MEMORANDUM: Local Map Amendment

SUBJECT **Local Map Amendment No. G-851 and associated Schematic Development Plan: Wildwood Medical Center, LLC**
Reclassification of 3.49 acres of land from the R-90 Zone to the O-M Zone for the property known as Lot N541, Parcel B, Wildwood Manor Shopping Center, located at 10401 Old Georgetown Road, Bethesda.

SUBJECT **Local Map Amendment No. G-851 and associated Schematic Development Plan: Wildwood Medical Center, LLC**
Reclassification of 3.49 acres of land from the R-90 Zone to the O-M Zone for the property known as Lot N541, Parcel B, Wildwood Manor Shopping Center, located at 10401 Old Georgetown Road, Bethesda.

BOARD ON BOARD FENCE DETAIL

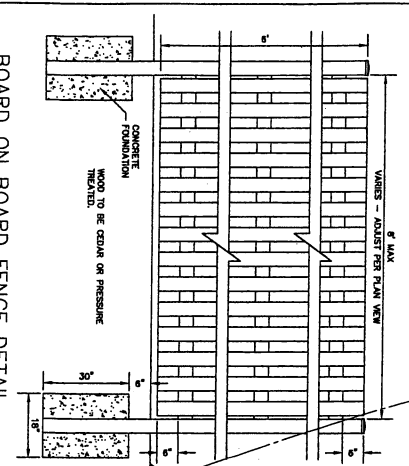
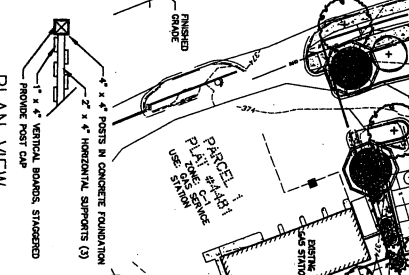
- (1) A six-foot high board-on-board fence;
 - (2) Shade trees;
 - (3) Evergreen plantings on both sides of the fence selected and located to block headlight glare.

Elevation 'C' - East facade of proposed building with landscaped buffer

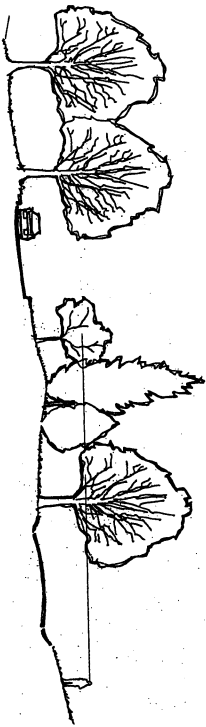
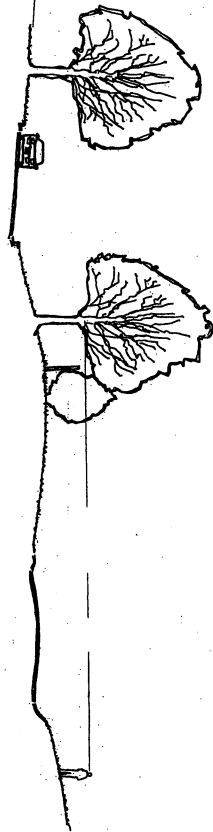
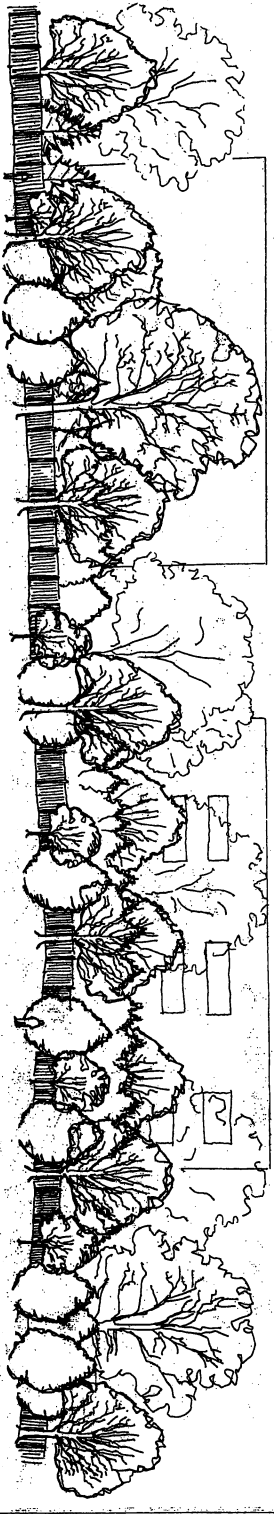
Your email correspondence, which Jody Kline has forwarded us, indicates that the height is to be measured from the front of the building. This leaves you, us, and the Planning Board with no information on the height from the rear of the building. Information on the height of the building on the Berkshire Drive side is crucial, because of the aesthetic impact on the residential community.

Elsabet. Along with any other changes to the Schematic Development Plan that may be recommended in your staff report and recommendation, we will change the text of the Binding Element for Building Height to read: "Not more than 3 stories or 42 feet in height as measured from the average elevation of finished ground surface along the front of the building (per the Zoning Ordinance)"
